ADDENDUM NO. 1
to
BIDDING/CONTRACT DOCUMENTS
for
**CONSTRUCT WEST APRON EXPANSION AND
INFRASTRUCTURE AT VPS**

DESTIN-FORT WALTON BEACH AIRPORT

Okaloosa County ITB AP 66-19

DATE: June 27, 2019

Drawing Name: **CONSTRUCTION ACCESS CONNECTION TO SR 85 N**

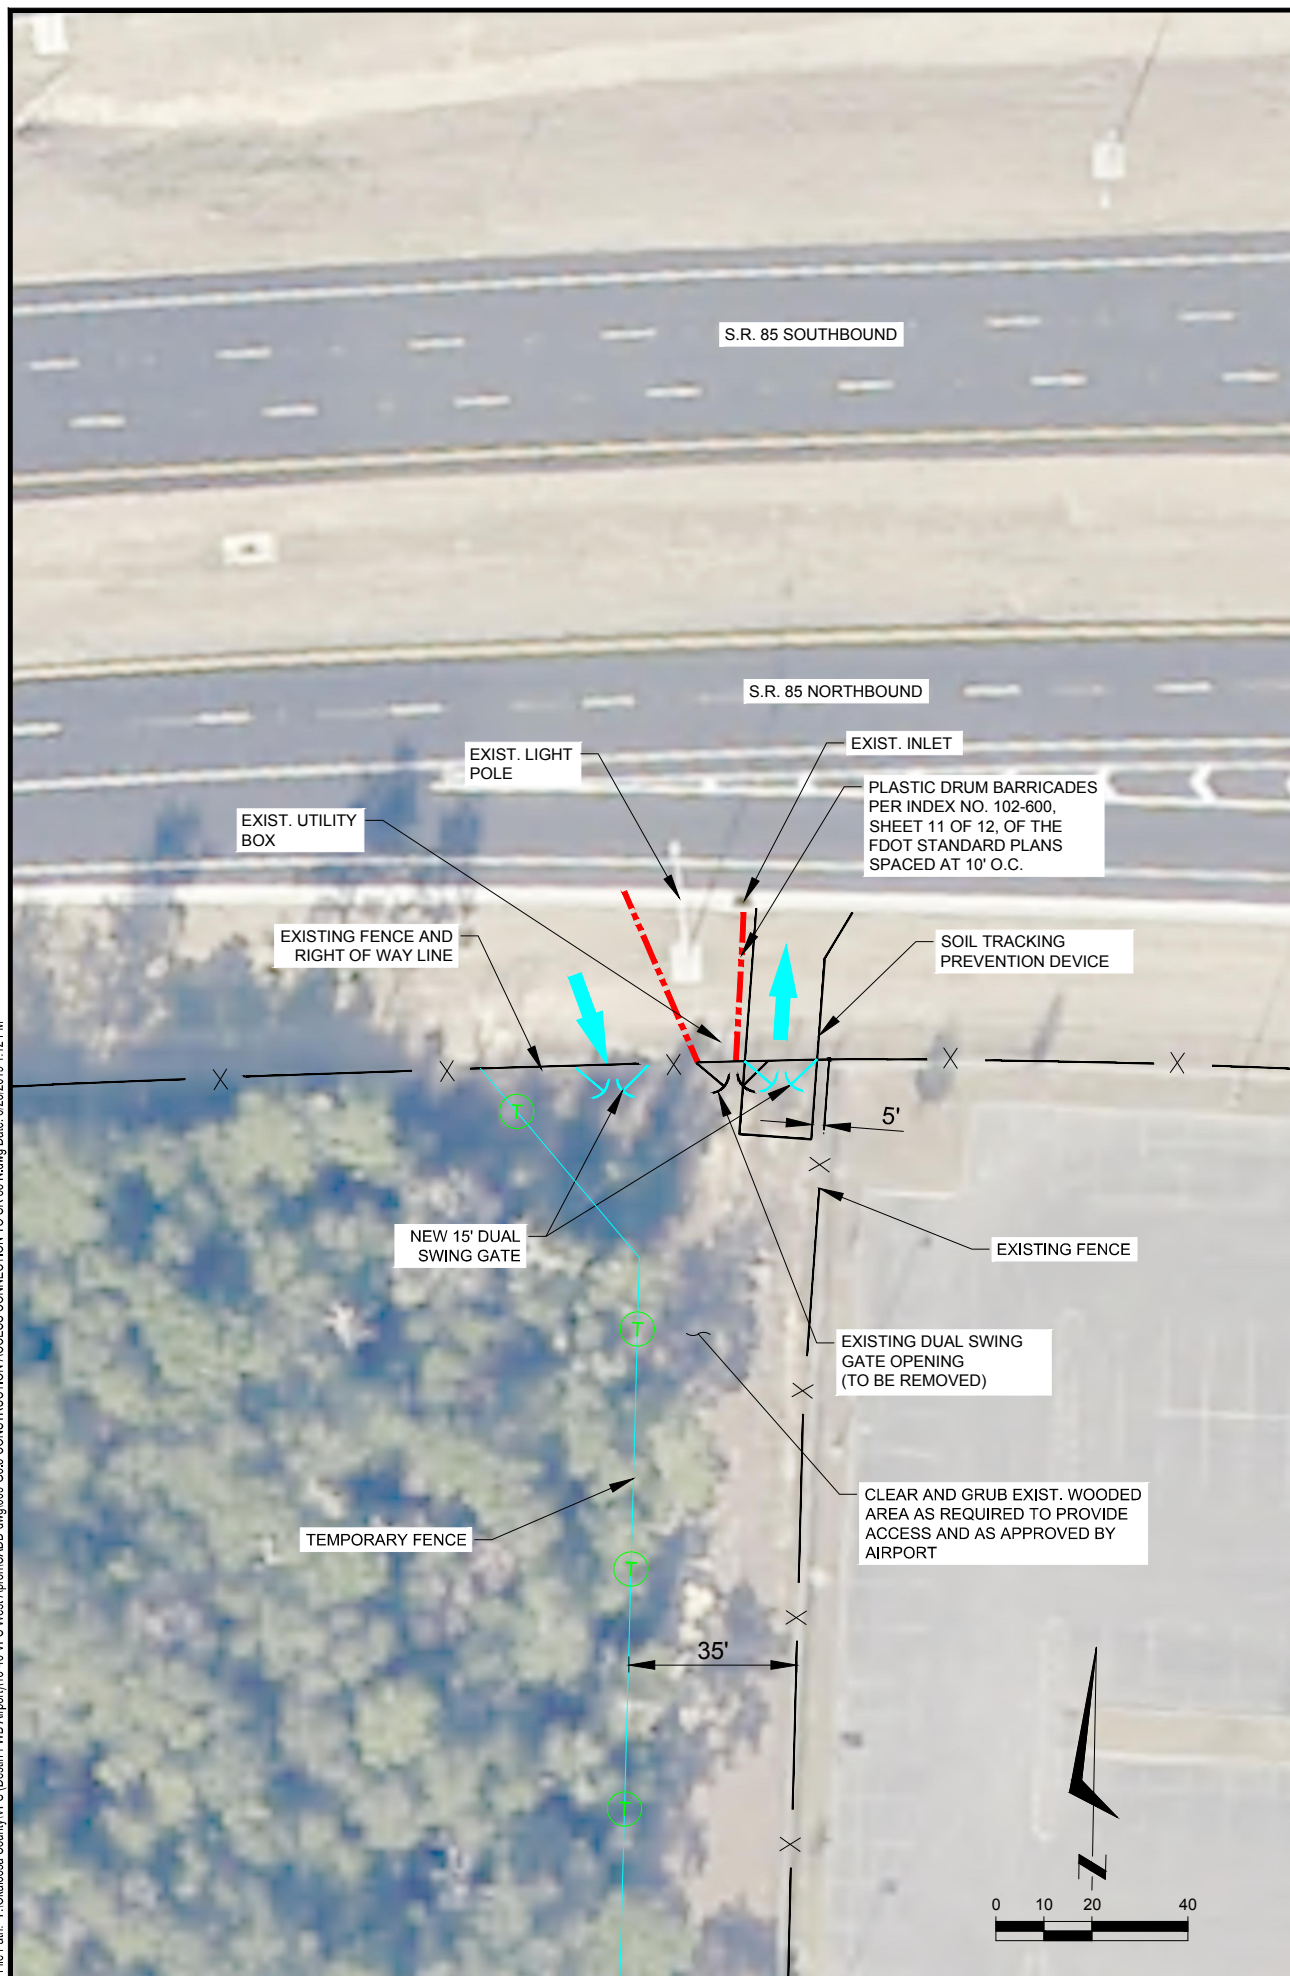
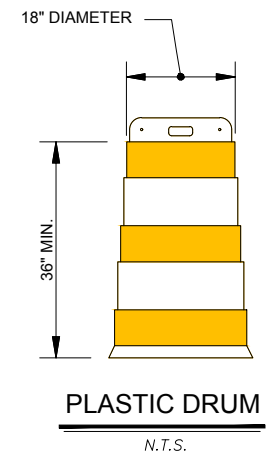
- 1. Add Sheet G3.5 – Construction Access Connection to State Road 85N.
- 2. Replace the Cover Sheet, and Sheets G1.1, G1.2, G3.1, C3.2, C3.3, C4.2, C4.4, C4.5, C4.7, C4.9, C4.10, C4.12, C7.3, C7.7, C8.1, C8.2, C8.3 and C8.8 with the attached revised versions.

Drawing Name:
MARKING AND SIGNAGE PLAN NO. 1

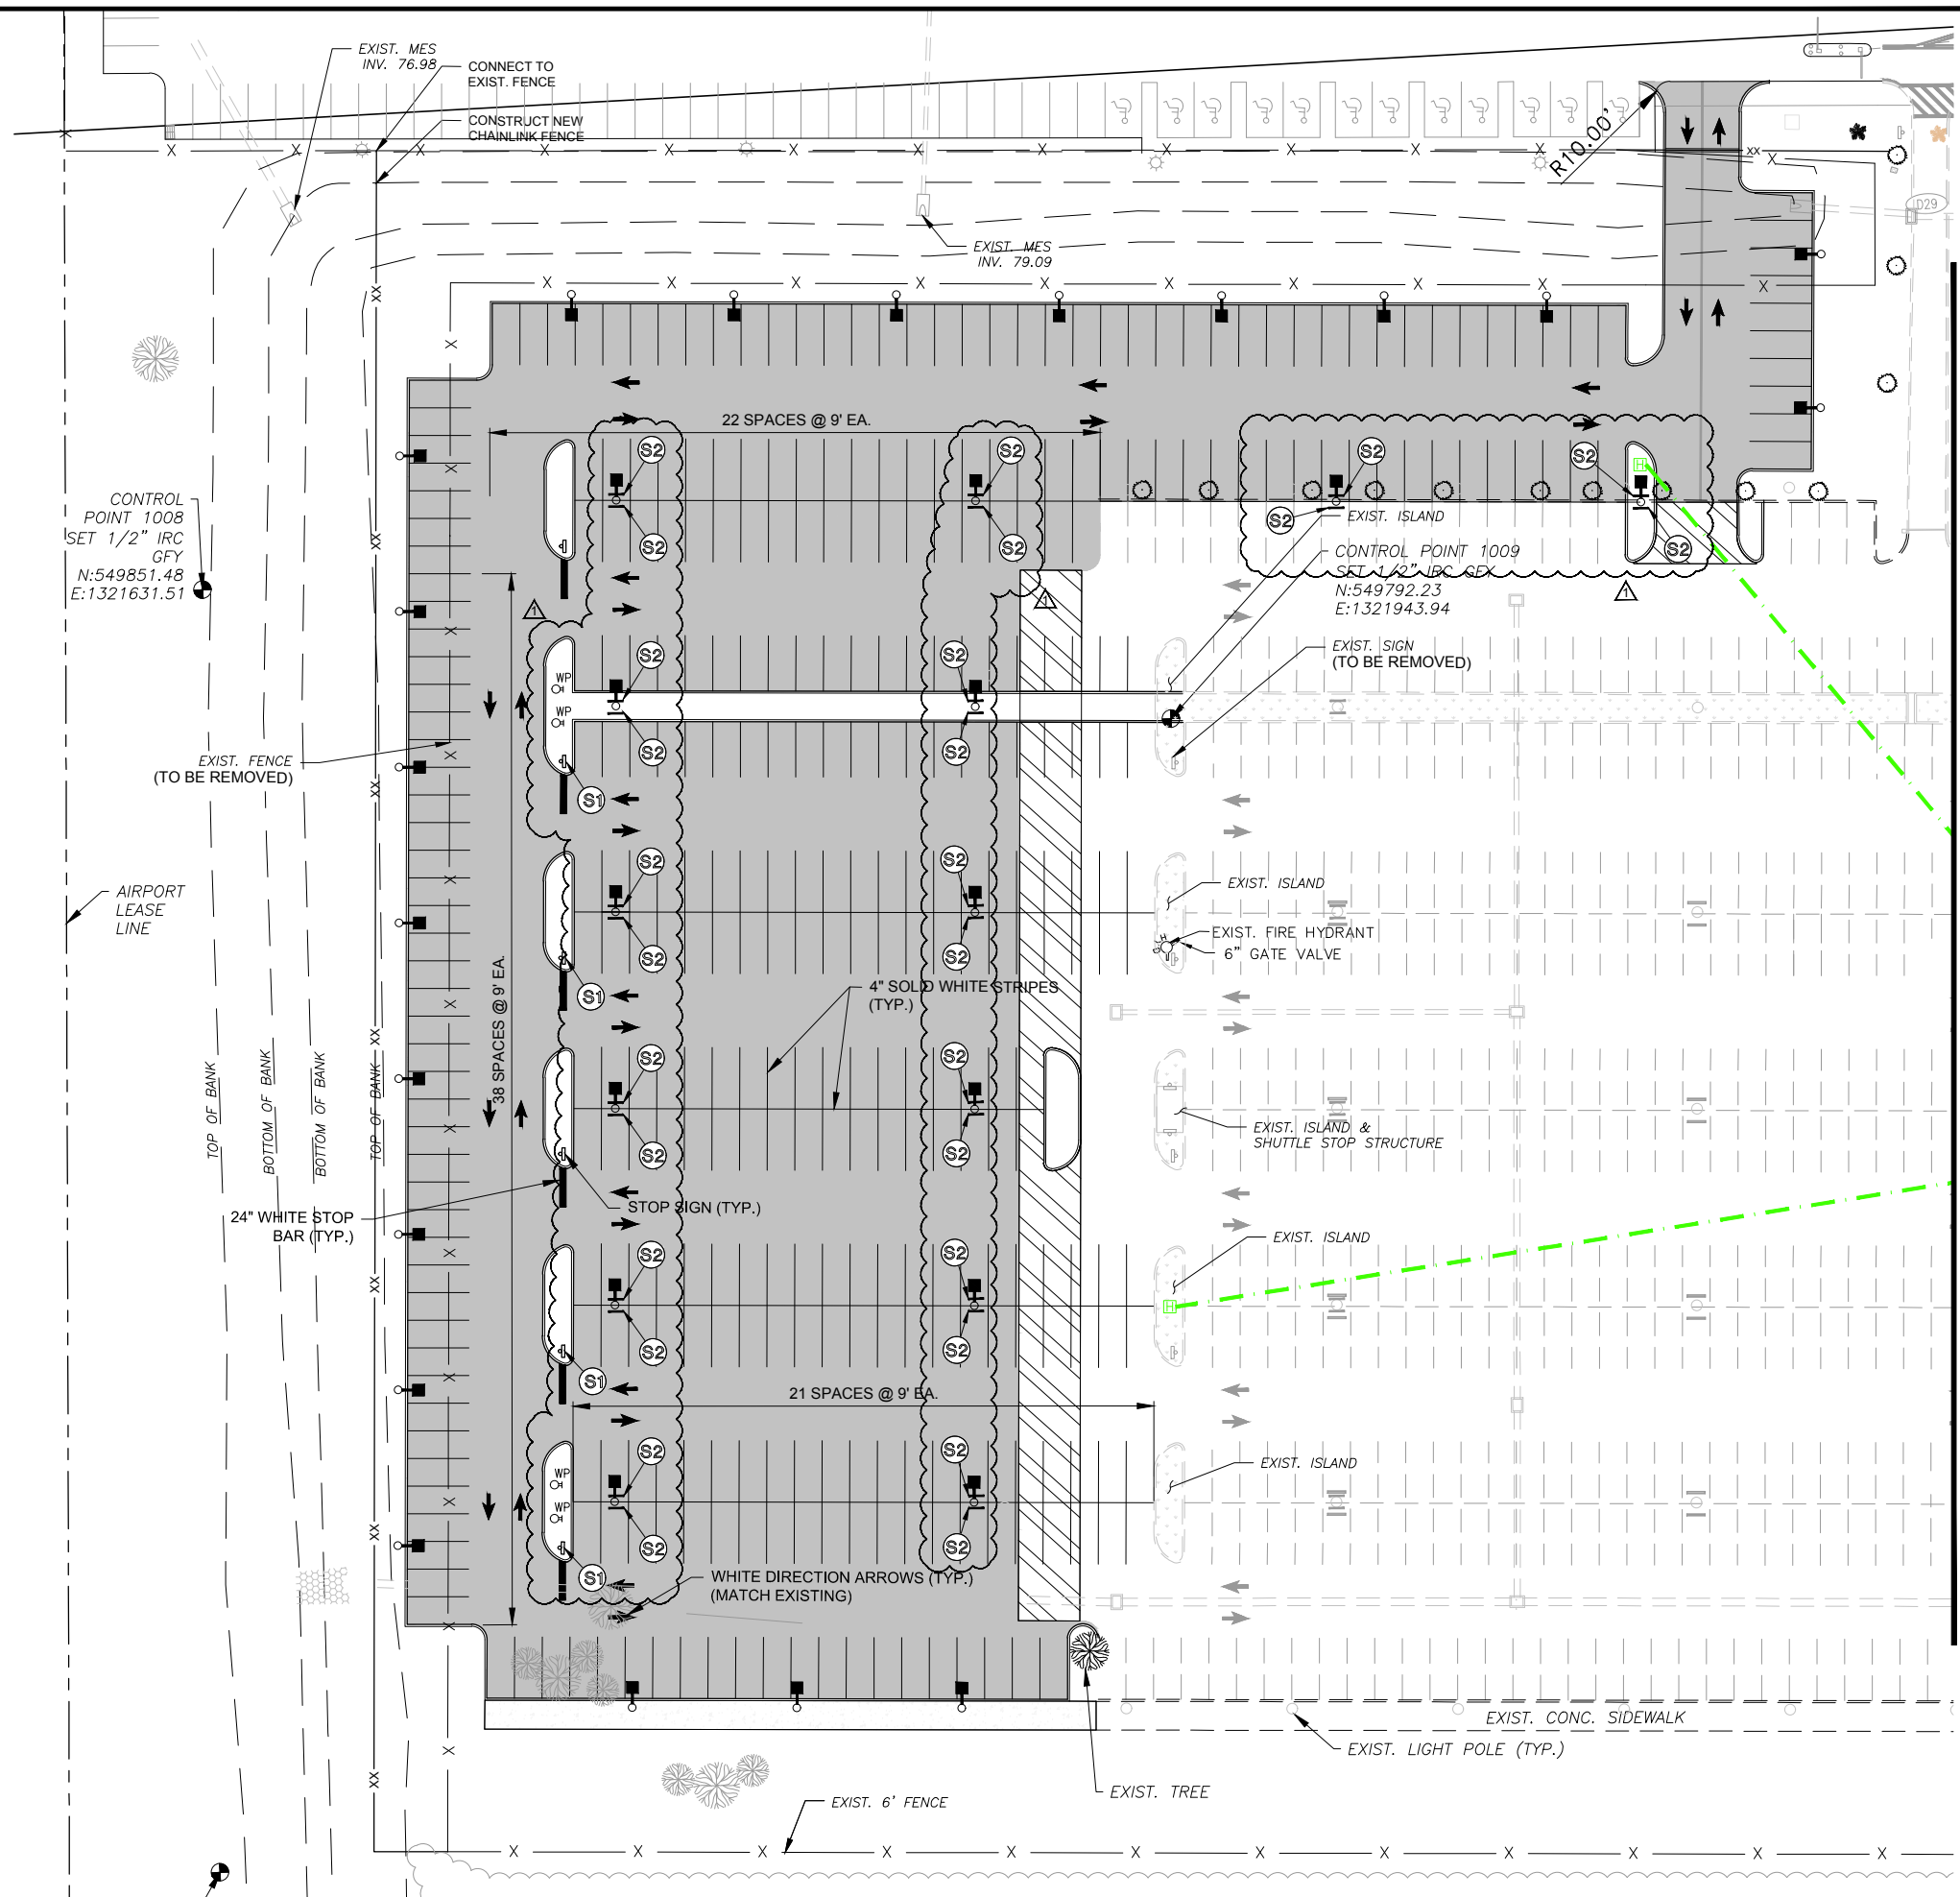
NOTE:
PARKING LOT AND BLACK OUTLINE MARKINGS ARE TO BE NON-REFLECTORIZED (WITHOUT GLASS BEADS). ALL OTHER APRON MARKINGS ARE TO BE REFLECTORIZED.

Drawing Name: **PUMP STATION SECTION AND LAYOUT**
FAA A.I.P. Project No.: **3-12-0081-029-2018**

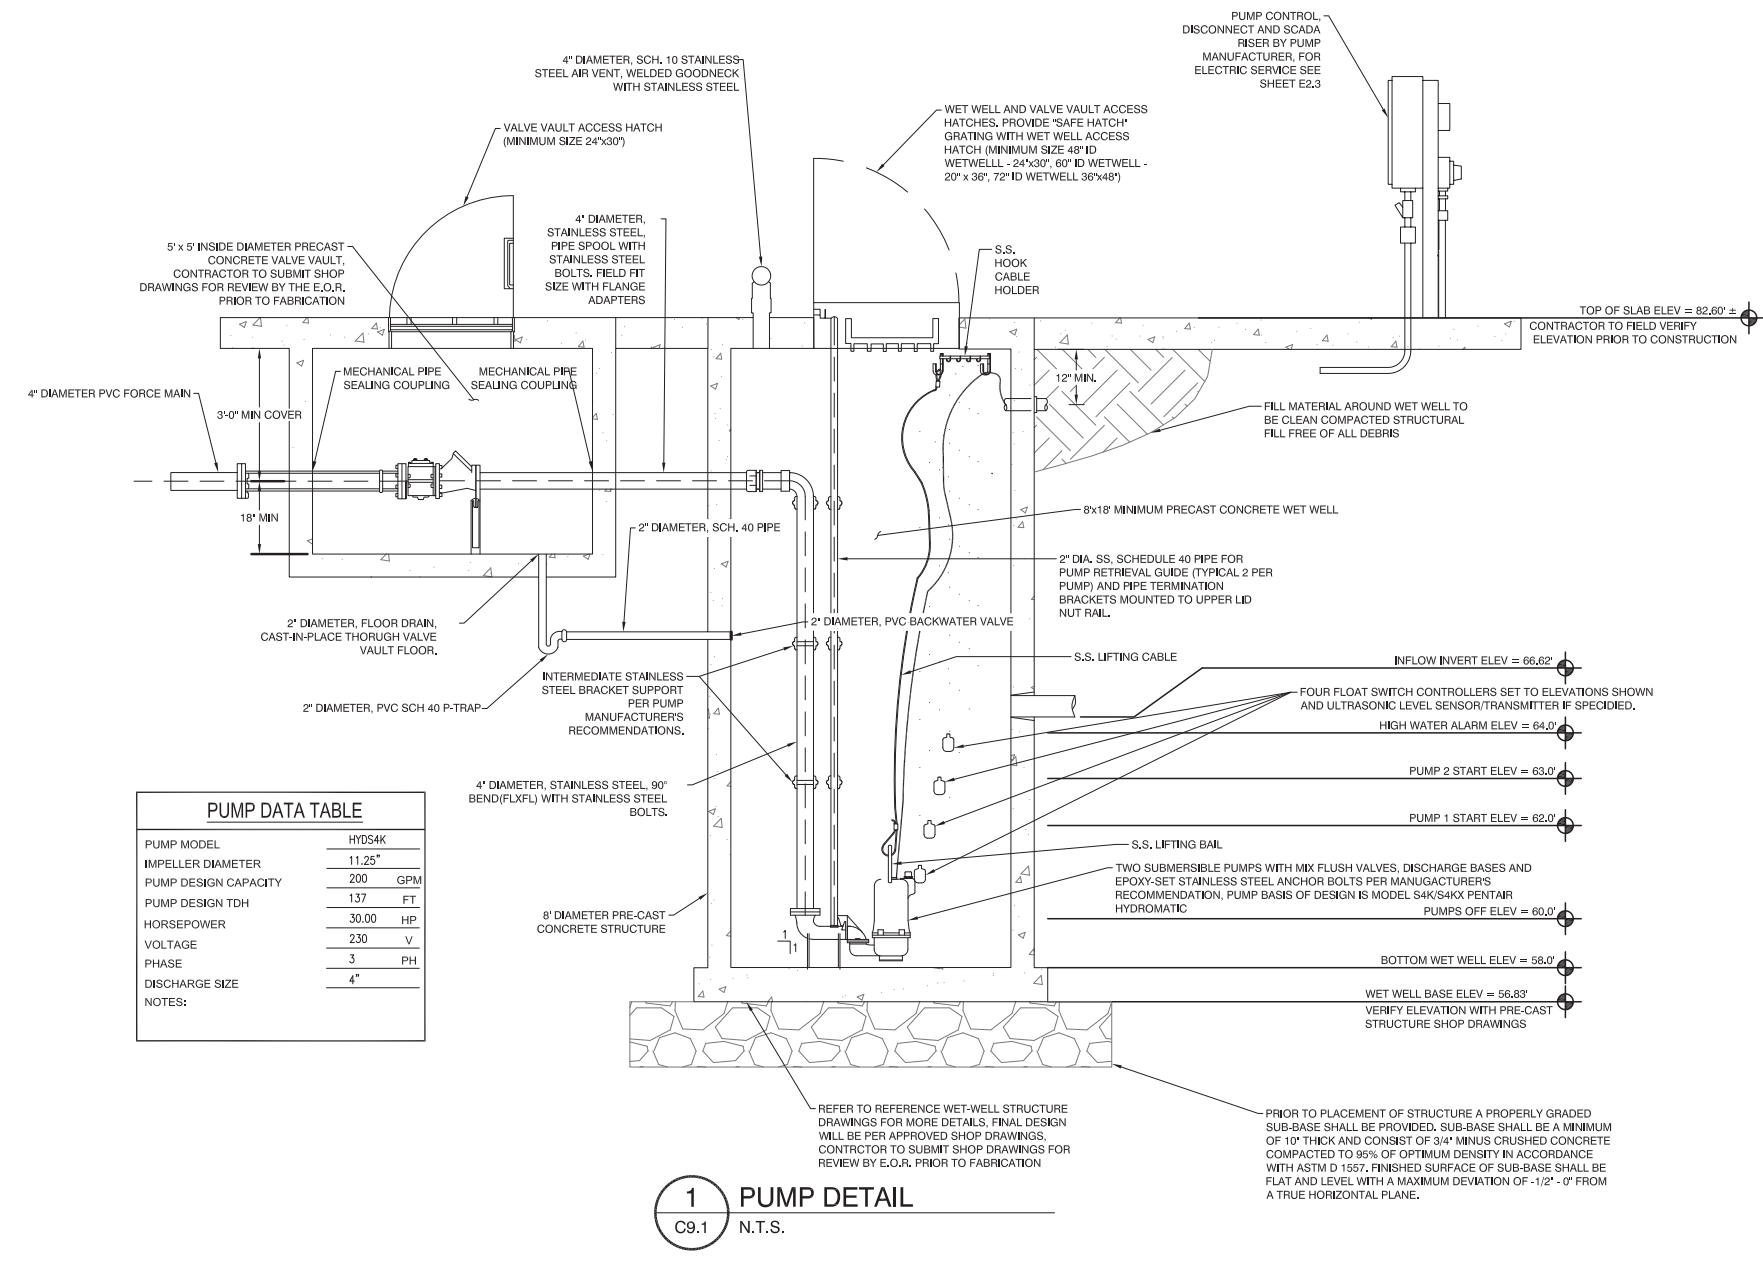
3. Delete Sheets C9.0, C9.1 and C9.2 dated Feb 2019 and replace with the attached revised versions dated May 2019. Please note these plans are for information only as the construction of the new sanitary sewer lift station and demolition of the existing lift station will now be included in the project as a Bid Allowance.
4. Delete sheets L1.0 thru L7.0 dated Feb 2019 and replaced with the attached revised sheets L1.0 thru L4.0 dated May 2019. Irrigation has been removed and comments to address County Growth Management requirements have been added.
